PLANNING COMMITTEE

ADDENDUM TO THE OFFICER'S REPORT

AGENDA ITEM 7

**15/07932.OUT – North London Business Park, Oakleigh Road South N11 1GN.
Pages 79-160**

As shown on our attached plan PS/01 in Phase 1 parking is located beneath Blocks 1C/D and 1E/F.

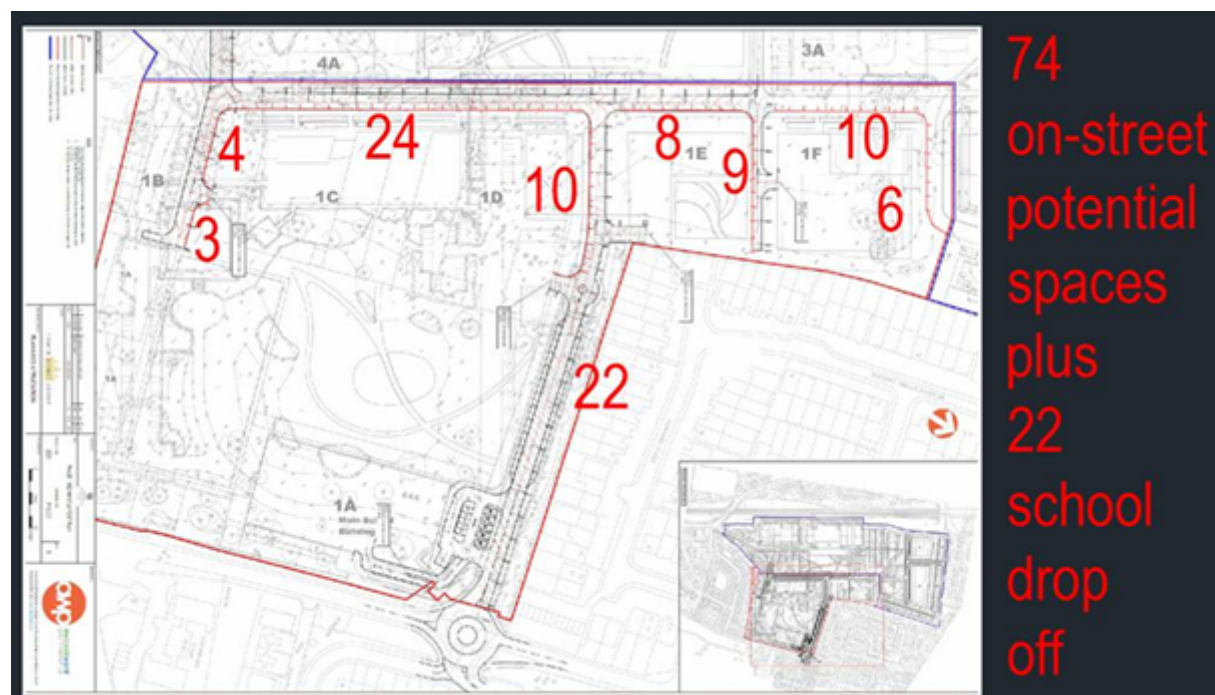
Accessible (disabled / blue badge) parking will be provided at a ratio of 10% of total spaces as below:

Accessible parking will be arranged within the basement car parks to be as close to each individual core as possible, to reduce the distance travelled by a disabled person to their vehicle. Further, clear routes which avoid traffic must be provided between the core entrances

and the accessible spaces to avoid potential conflicts with vehicles and this is particularly pertinent when considering wheelchair users.

For the entire scheme, the parking ratio is 1.41 and is within DM17 standards. All parking matters are secured by condition 18.
